Model	VT2100/2130/2150, Ges5310/5315/5320, Rex1240/1241/1242, NSA CP310/315	Volt/Hz	Date of Modification	Serial Number
Modified Article	Parts Catalog			
Reason for Modification	Parts catalog correction

Model		VT2100/2130/2150, Ges5310/5315/5320, Res1240/1241/1242, NSA310/315					Volt/Hz	Date of Modification	Serial Number	
Modified Article		2nd Feed Roller Gear								
Reason for Modification		To improve the durability of the 2nd feed roller gear								
Draw No.	Old Parts No.	New Parts No.	Description	A.B.C.	Q'ty Used Old → New	Inter-change-ability	Part needed for replacement by new part		Parts Catalog	
				Rank			Part No.	Description	Index No.	Page
	C2035231	C2075231	Gear - 14T			X/O			12	27

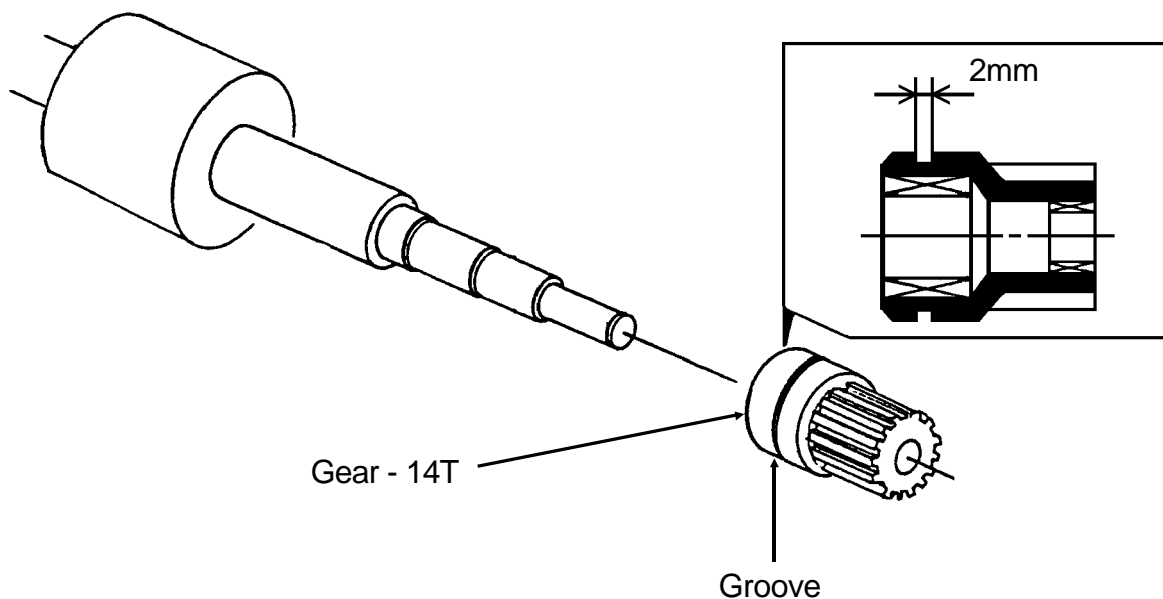
It was reported that on some machines in the field, the image position varies. Although this is a very rare case, at worst this happened after making about 200,000 prints. On the problem machine, the one-way clutch inside the 2nd feed roller gear slips just when the 2nd feed rollers start feeding a sheet. (The paper feed start timing is delayed.) This makes the image position vary, i.e. move up or down in paper feed direction. After investigation, it was found that the grease inside the one-way clutch changes in quality and damages the inside surface of the clutch. The new 2nd feed roller gear contains a new type of grease that does not change in quality unlike the old one. To distinguish the new gear from the old one, a groove is made on the new gear.

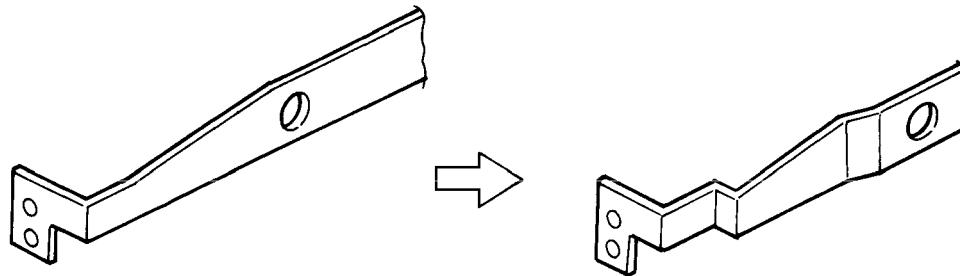
When the paper table is lowered, the feed roller arm contacts the side pad lever if the paper feed side plates are fully opened. To prevent this, the shape of the feed roller arm has been changed as shown in the illustration below.

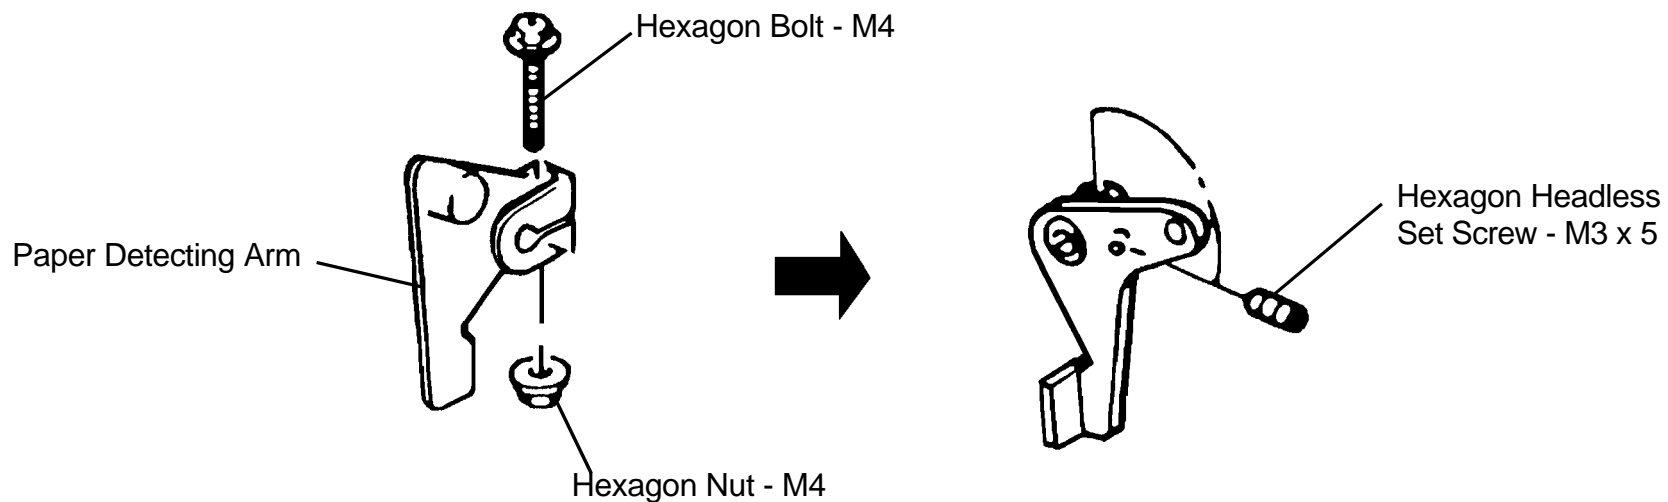
To improve strength and durability, the paper detecting arm has been changed to the type used on the NA2 (C210).

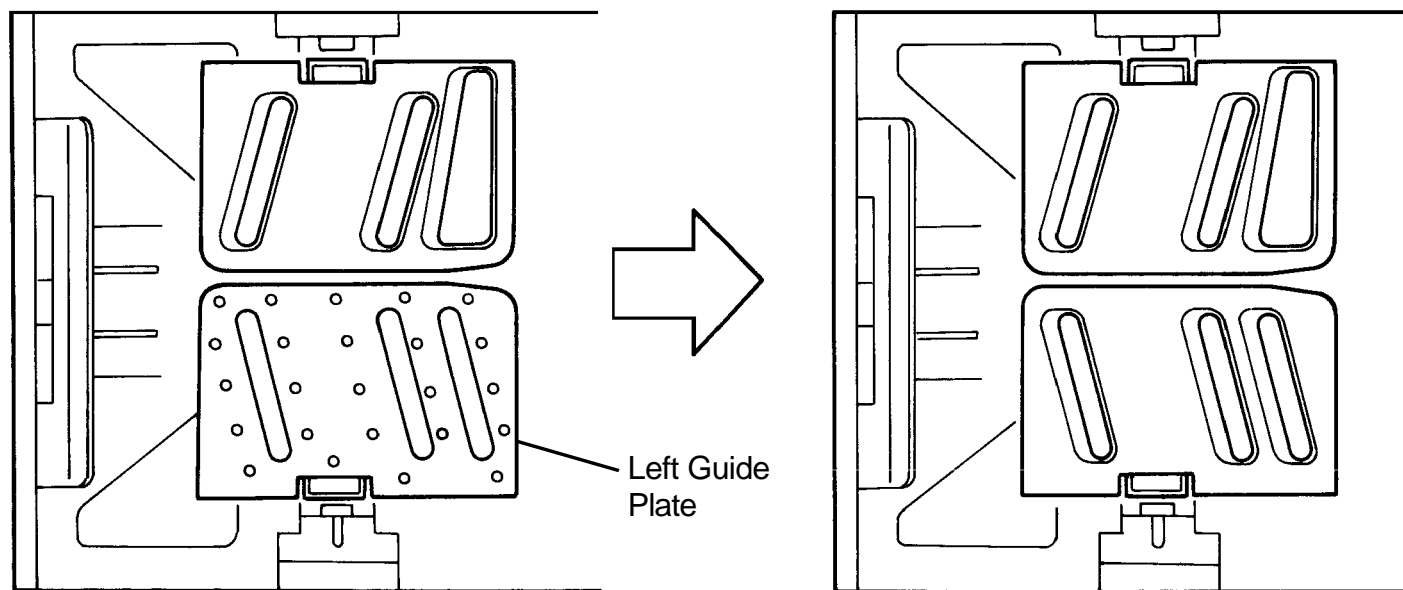
The right guide plate of the priport VT2000 series was changed from that of the priport SS series in order to allow for the installation of the tape dispenser unit. As a result, the appearance of the right guide plate was different from the old one. This was visible especially when the right and left guide plates were closed. (See figure)

Now the left guide plate has been changed to match its appearance with that of the right guide plate. The difference between the new and old one is only in the appearance of the backside (Interchangeability is O/O).

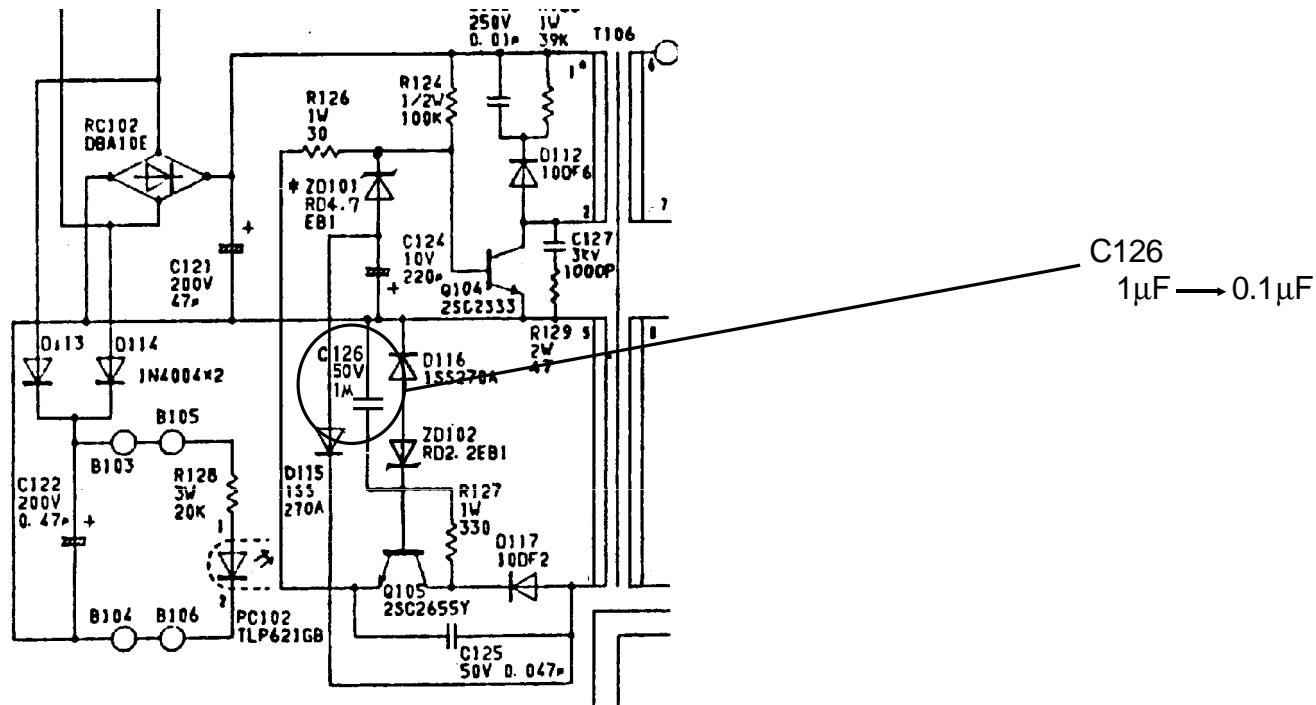
At the factory, it was found that the machine sometimes fails to start working if an operator repeatedly turns the main switch on and off very quickly. In this case, dc 5V is not supplied.

A capacitor used in the power supply unit has been changed so that power supply circuit responds quickly.

Part number of the power supply unit has not been changed but suffix has been changed to A.

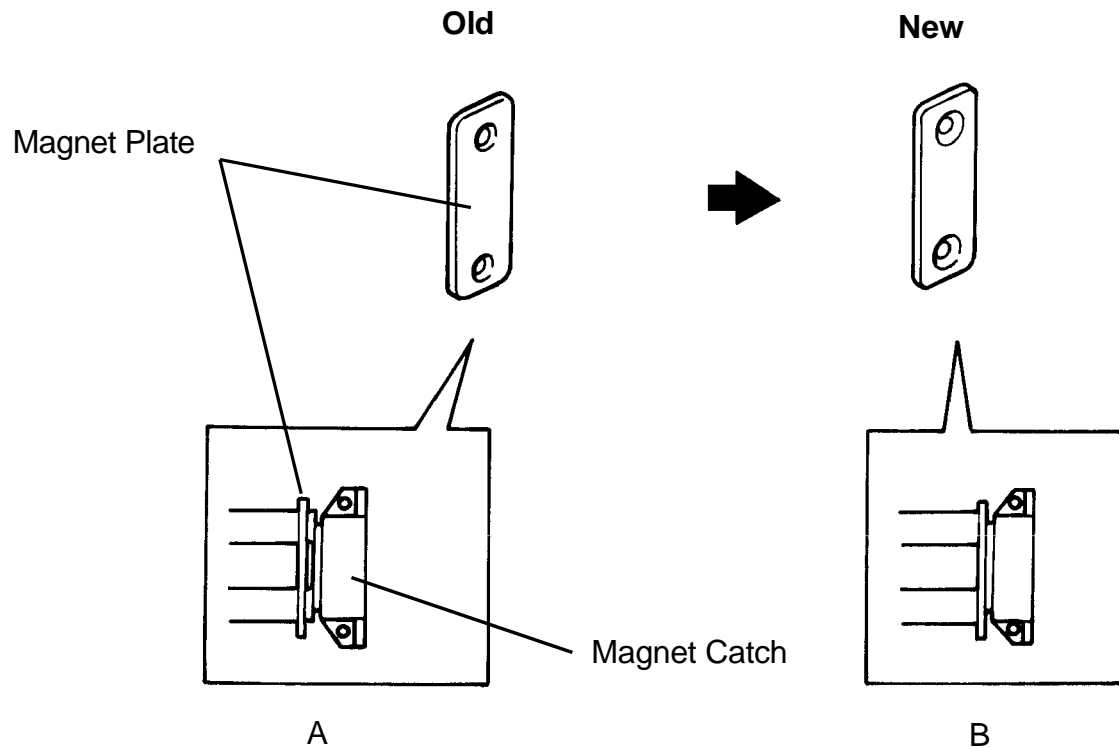
In VT series, the flat head screws fixing the magnet plate project out of the holes of the magnet plate because the heads of the screws are a little bigger than the holes. This weakens the attraction between the magnet catch and the magnet plate (illustration A).

To increase the attraction, the holes of the magnet plate have been made bigger so that the magnet sticks the magnet plate tightly (illustration B).

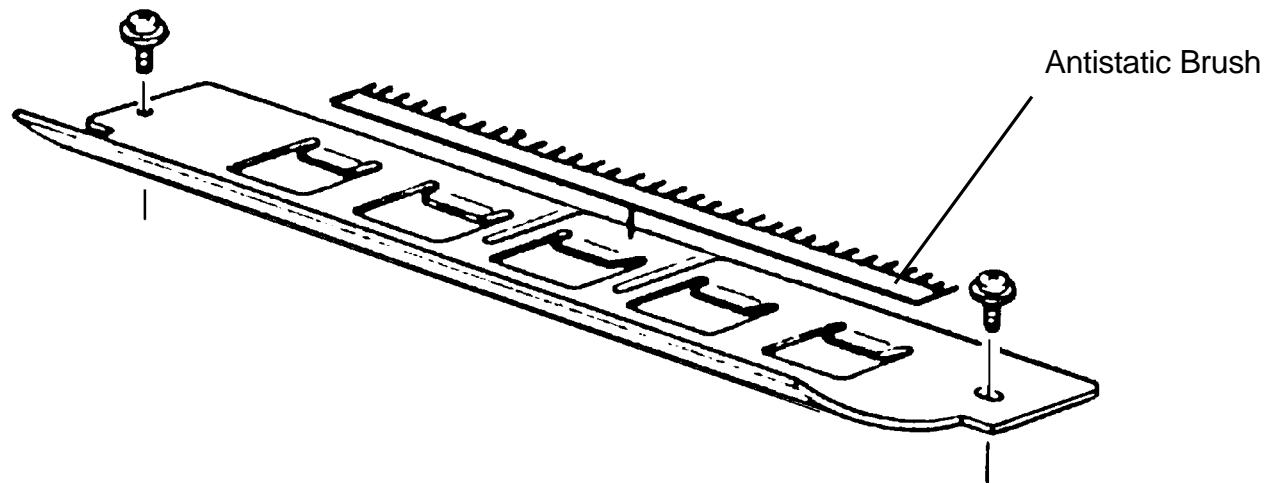
To prevent paper jamming under low humidity conditions caused by static electricity on the paper, an antistatic brush is added on the upper second feed roller guide plate. Refer to RTB No. 3 for details.

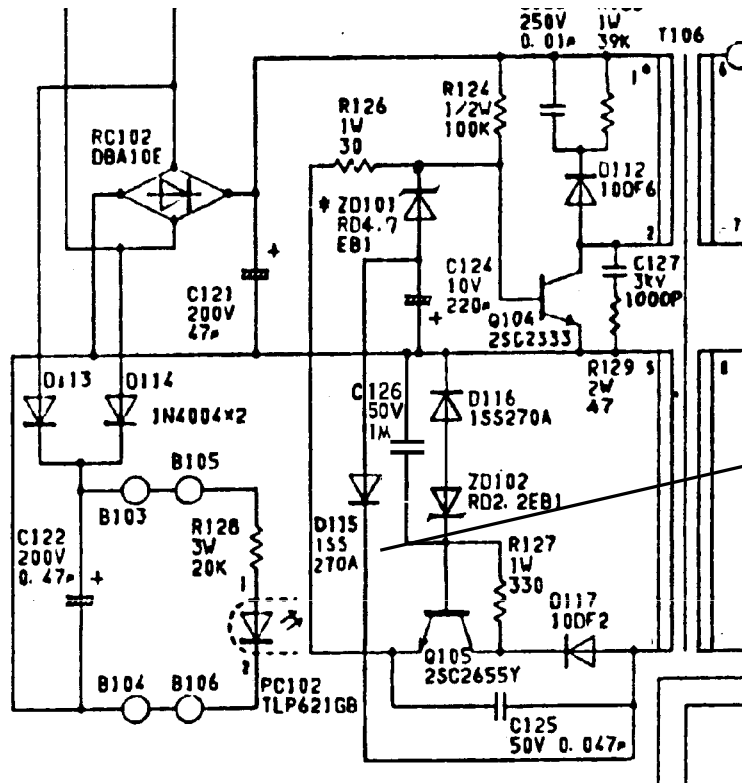
To ensure that the power supply circuit responds quickly (Refer to the MB No. 7), a ferrite core is added to the anode of the diode D115.

Part number of the power supply unit has not been changed but suffix has been changed to B.

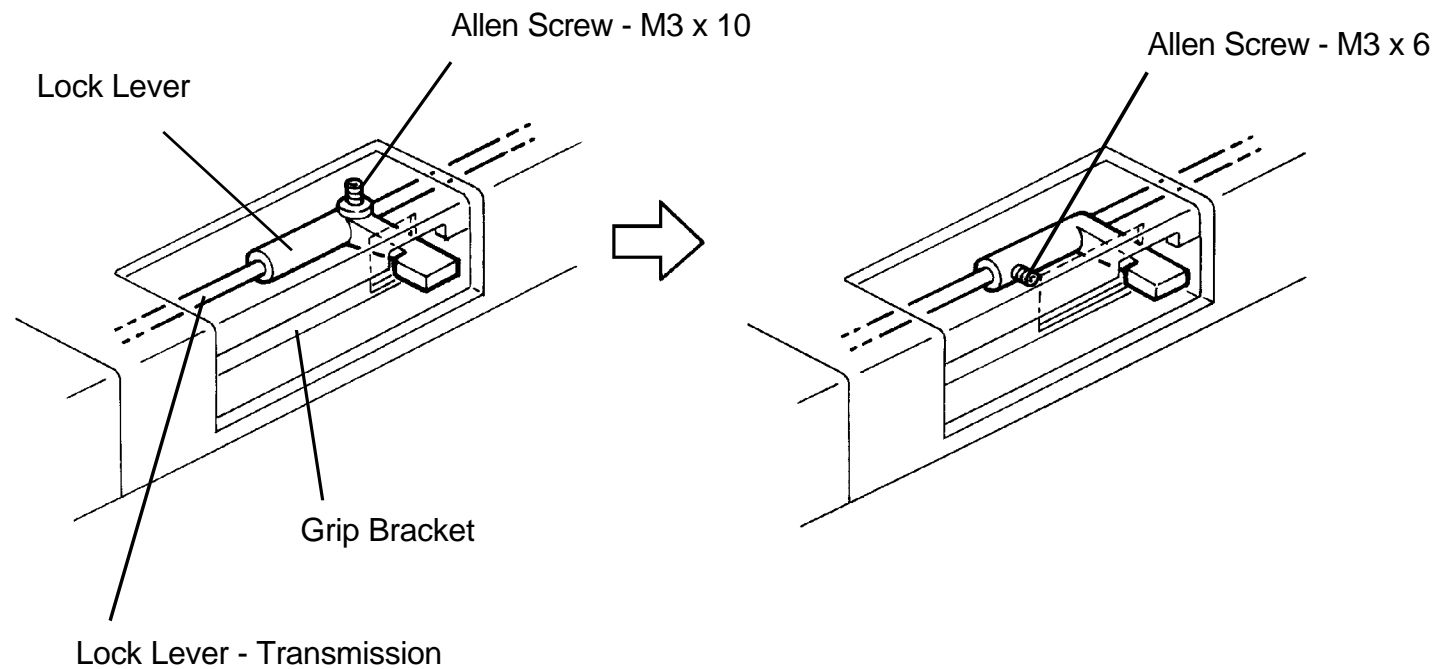
In the present machines, it is difficult to tighten the screw fixing the lock lever to the shaft. It is necessary to remove the scanner unit to access the screw.

To facilitate servicing, the direction of the screw has been changed and the cutout of the bracket has been enlarged so that a customer engineer can access the screw from the cutout of the bracket.

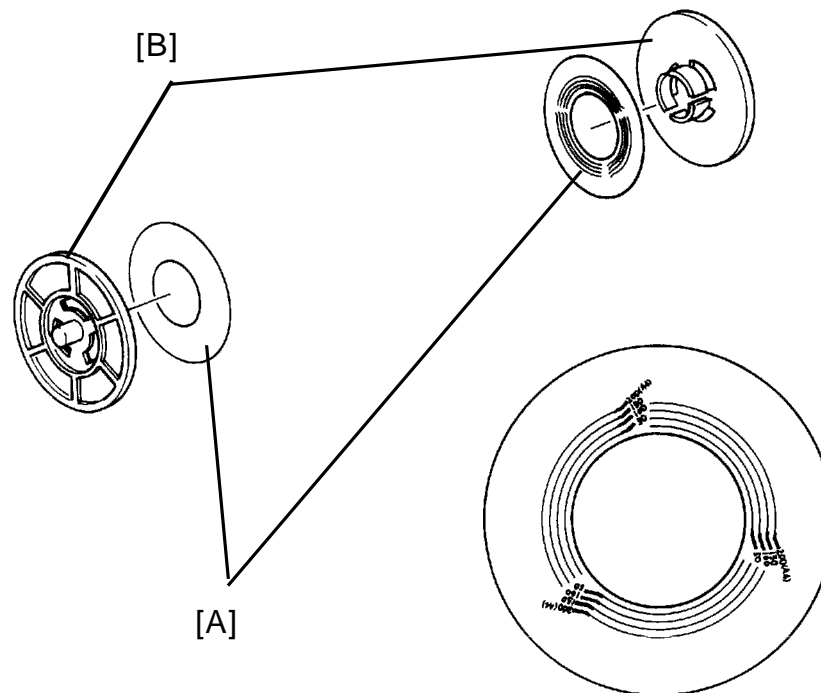
A master flange decal [A], which shows how much master is left on the roll, has been added to the master roll flange [B]. The following table shows the machine type, flange, and decal combination.

Illustration 1

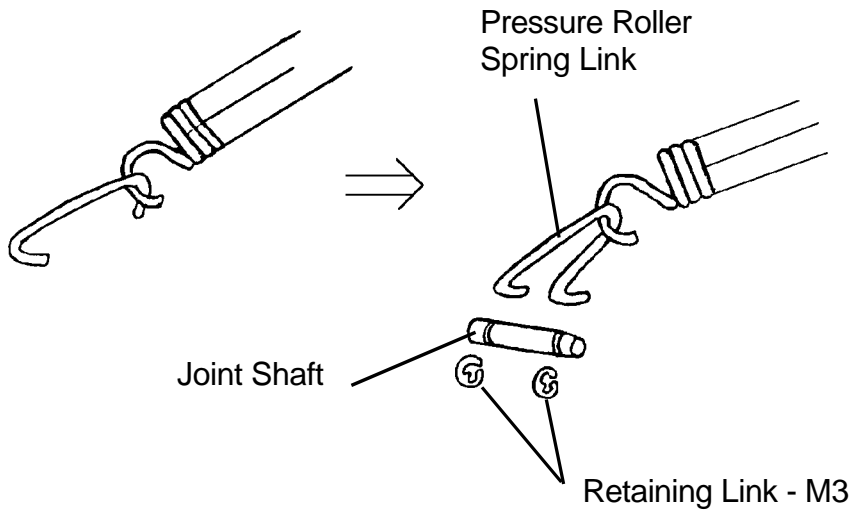
To increase the reliability, the pressure spring link is modified as shown in the illustration 1. Due to this modification, the adjustment value of the bolt clearance [A] has been changed as shown in the illustration 2.

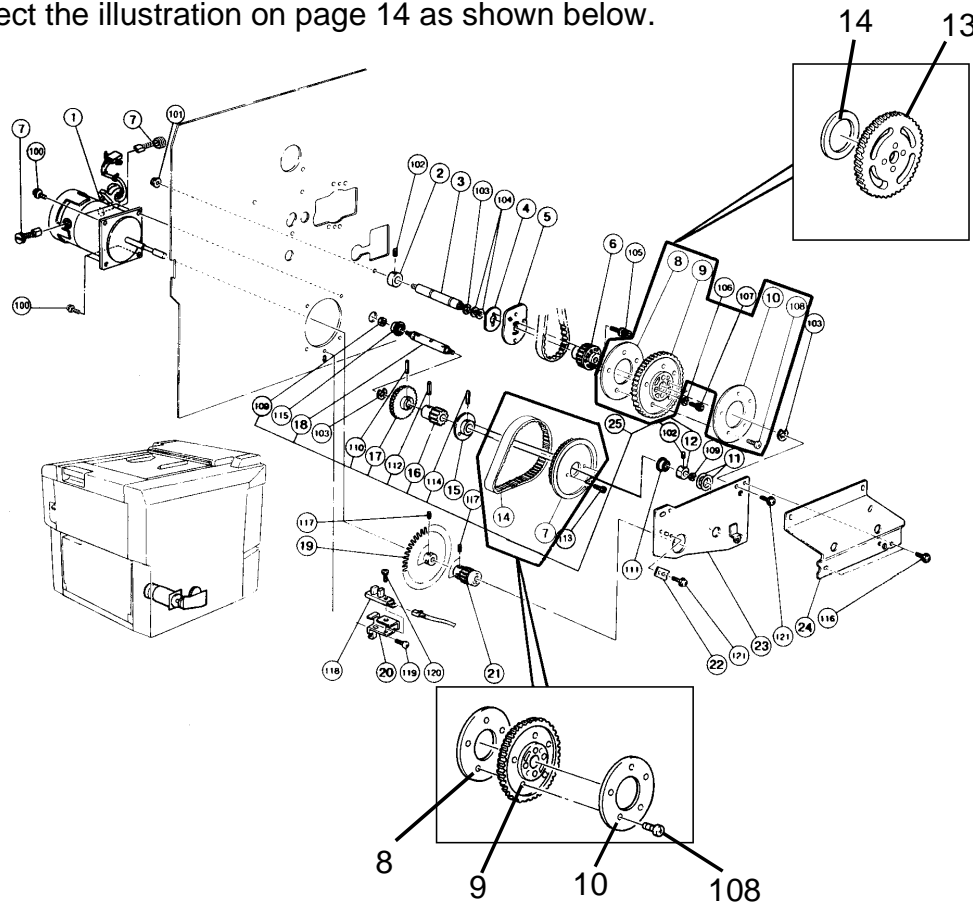
Please correct the illustration on page 14 as shown below.

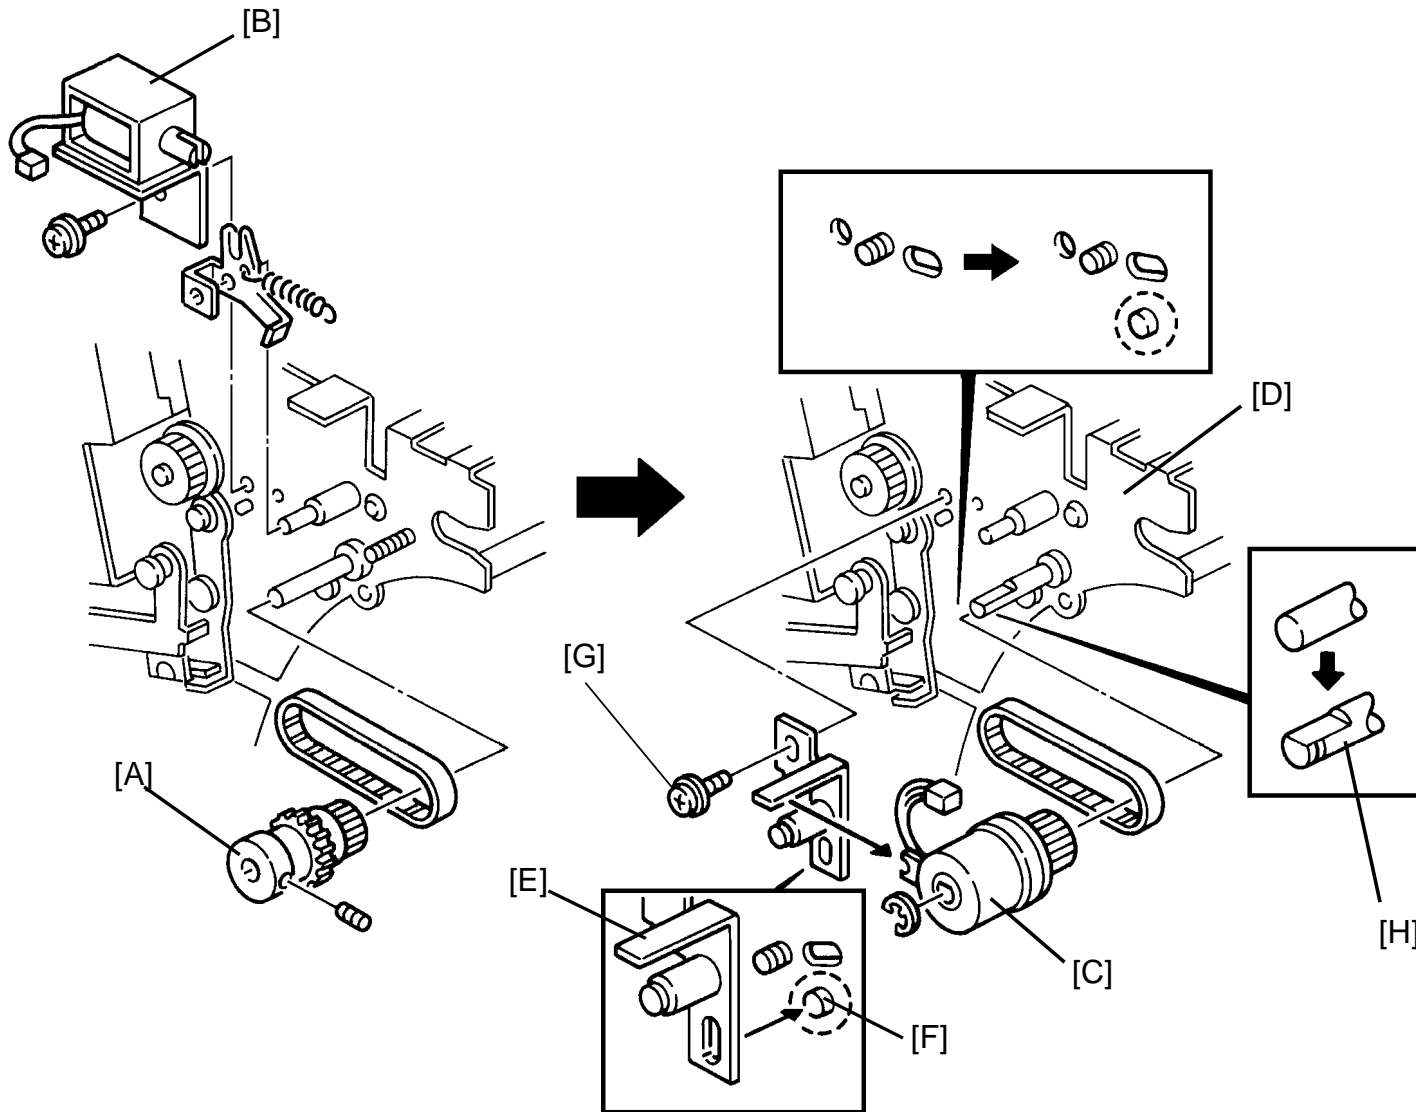
It has been found that a horizontal thin white line appears 64 mm from the leading edge of prints. The line may be visible when the image is made using the photo mode. This line is caused by a shock wave when the master is clamped by the drum master clamber.

1. To erase this white line, the software has been changed to delay the timing of the master clamping. With the old software, the reverse roller solenoid [A] and the master clamber solenoid were turned off at the same time. (Due to the slow response of the old spring clutch, the reverse roller stops feeding the master after the master was clamped.) The new software enables that the master is clamped when the master is fed 2 mm further after the reverse roller stops feeding the master. This allows to make a small buckle of the master, which absorbs the shock wave, between the platen roller and the reverse roller before the leading edge of the master is clamped.
